**ADDENDUM NO. 1**

Building 621 Renovations, Keaukaha Military Reservation (KMR), Hilo, State of Hawaii,  
Department of Defense, Hawaii Army National Guard,  
Job No. CA-1212-C3

# PROJECT IDENTIFICATION SIGNBOARD

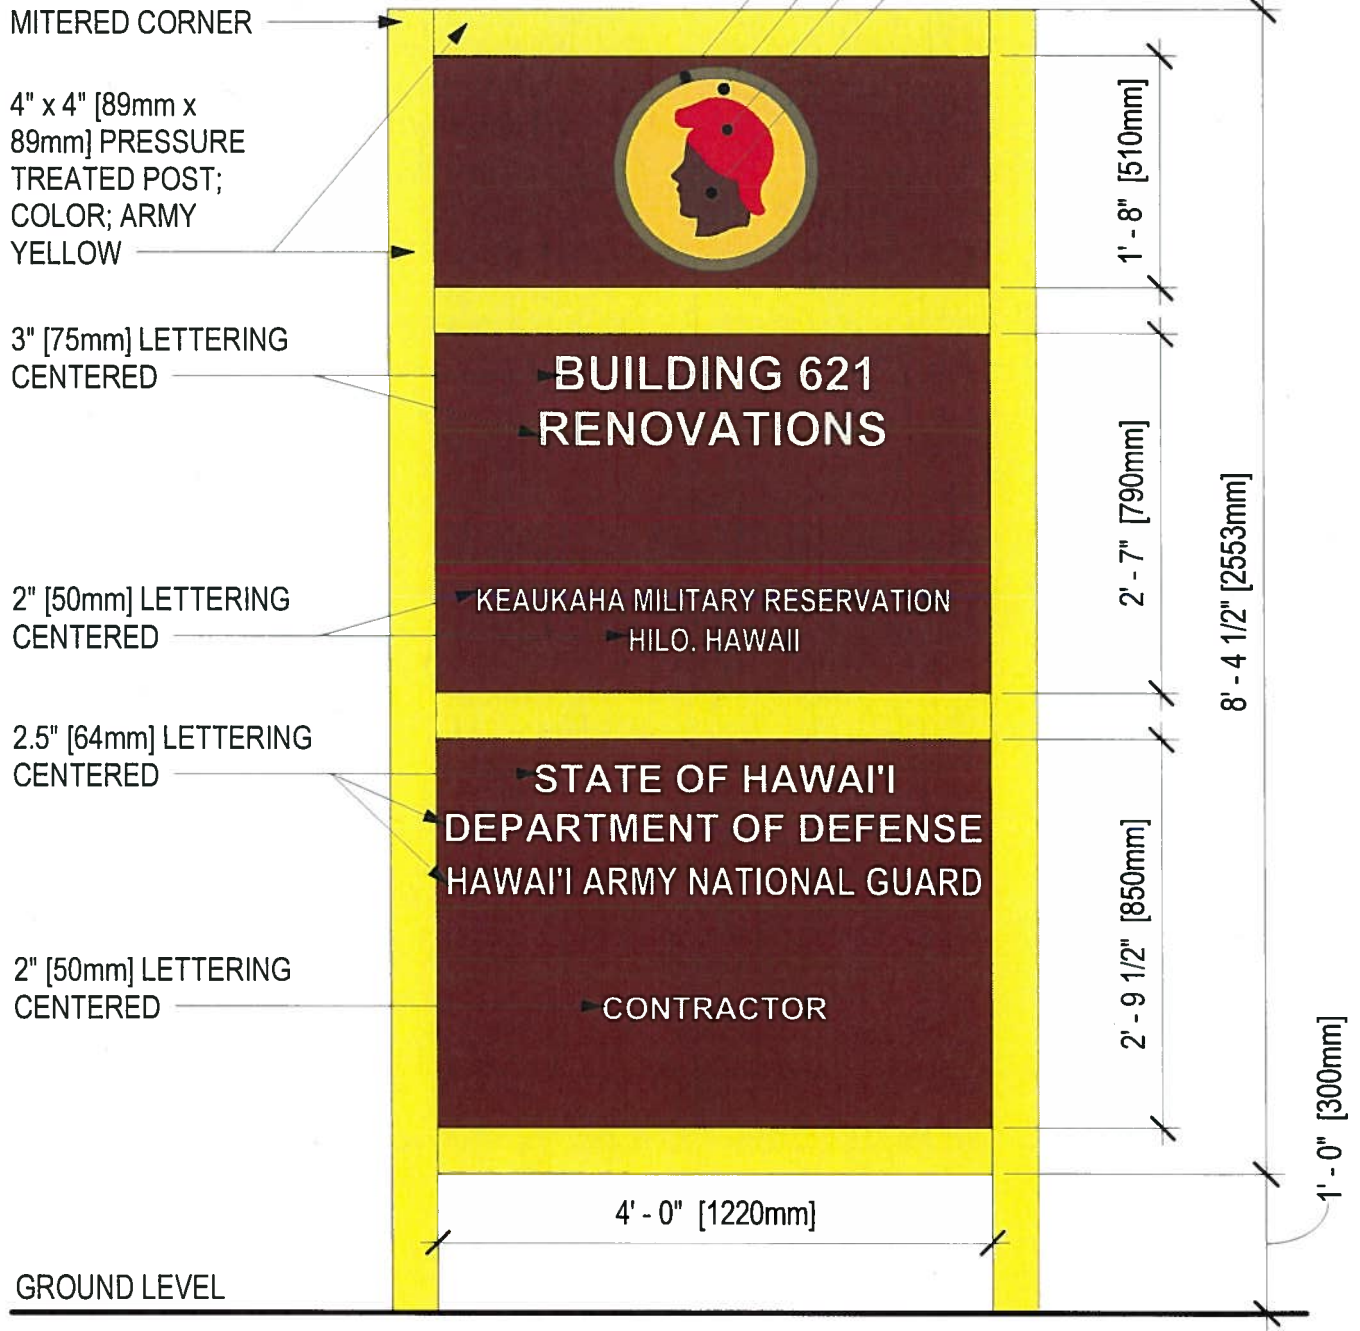
Q2. Can you please provide details and drawing of the project sign? The snip below is from the Special Provisions 01500-8.

1. Provide and install project identification sign and other signs as listed.
  - a. Project Sign: As indicated In Drawings.

*A. The attached sketch dated 11/21/19 replaces detail A3 on drawing A-702.*

**HIARNG - ARCHITECTURAL SITE PLAN**  
 SCALE: 1" = 48'-0"

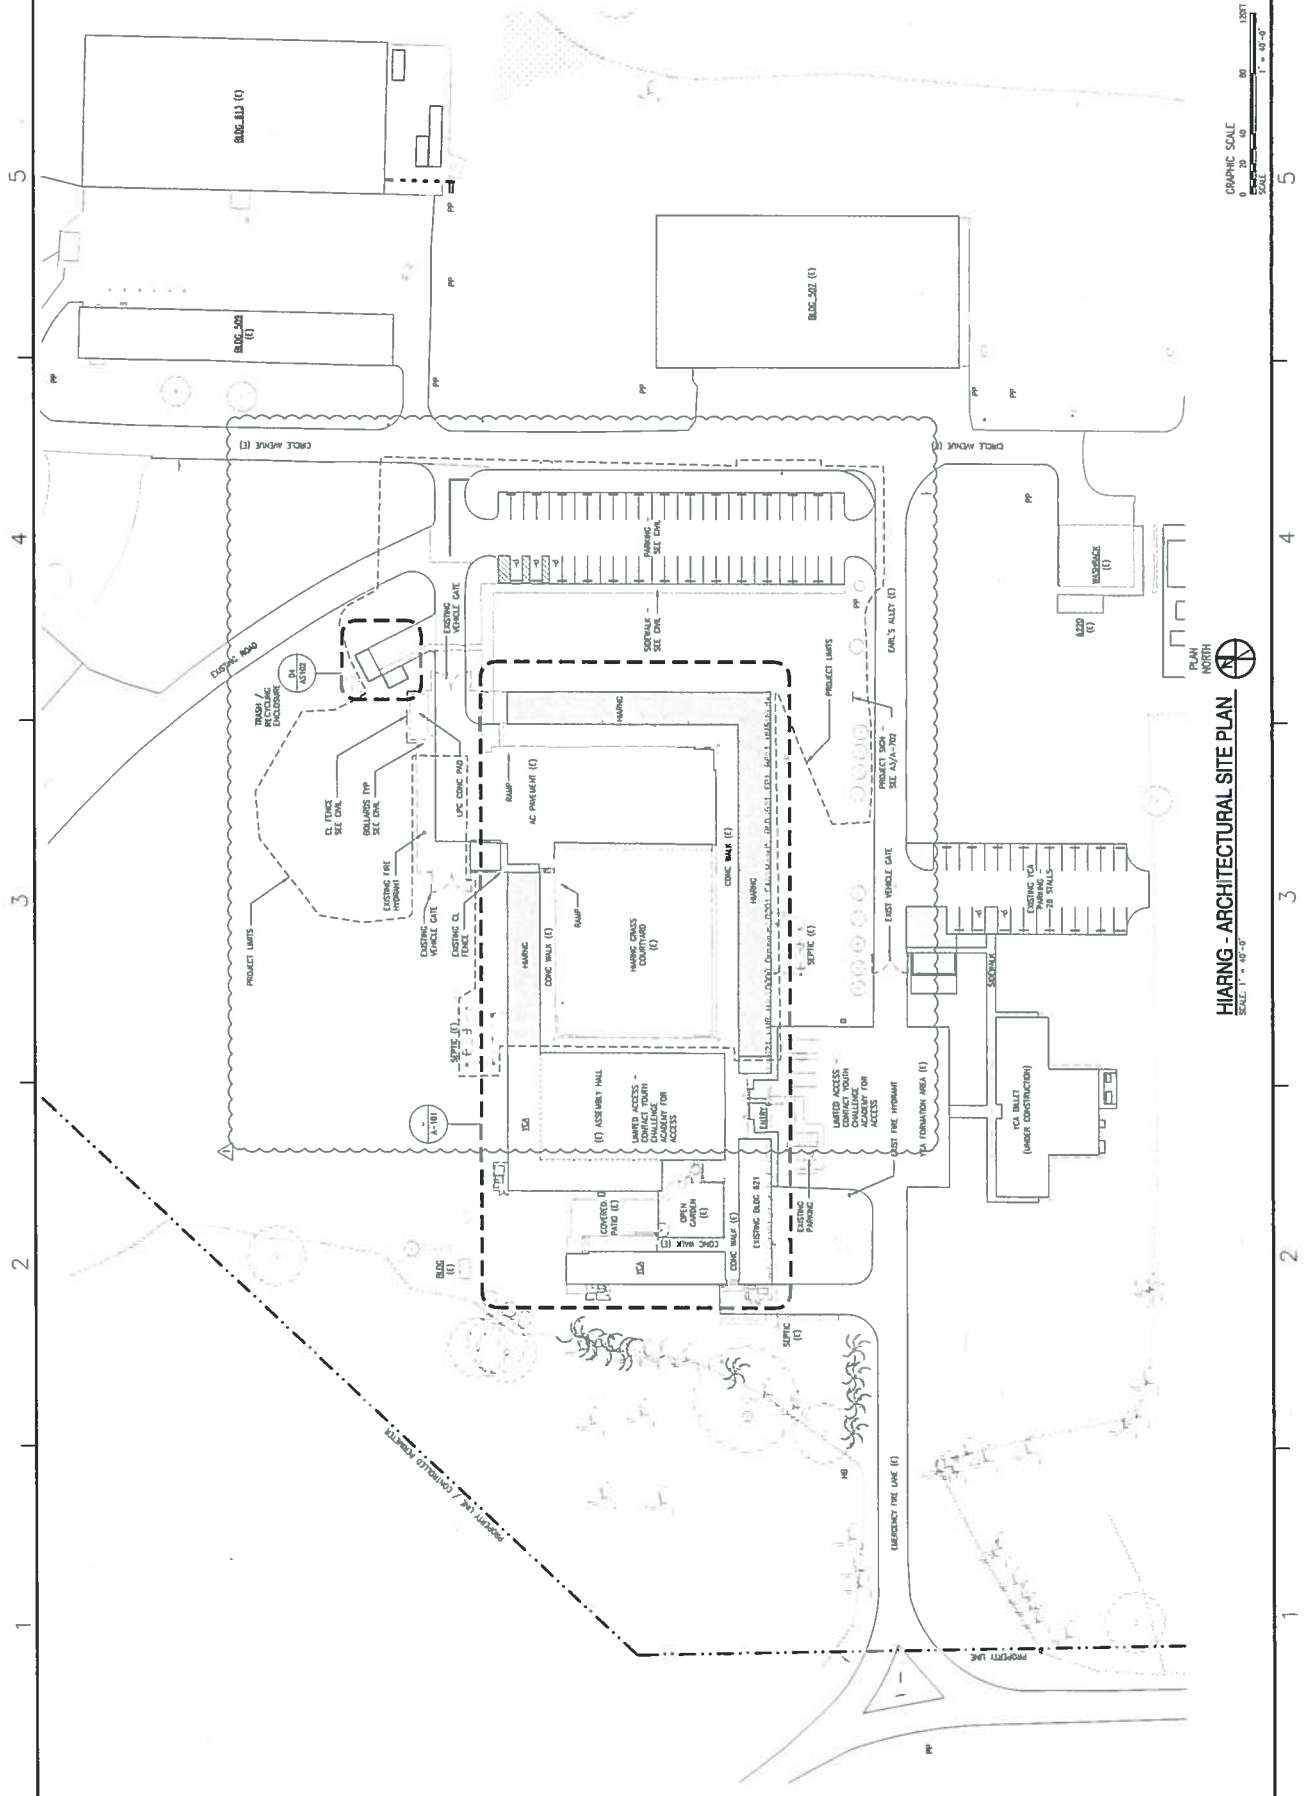
Q10. Project Limits identified on Drawing CG-101 do not incorporate parts of Building 621 which have architectural and mechanical scopes of work to be completed. For safety reasons, access to these areas should be restricted to construction personnel only. As a result, the center courtyard area, or portion thereof, should be allocated to Contractor and included within project limits. Please advise.

*A. CS101 indicates Civil scope limits. See Architectural Site Plan for Overall Project Limits. Replace Drawing Sheet AS101 with attached Sheet AS101 Addendum No.1, dated 11/20/19.*
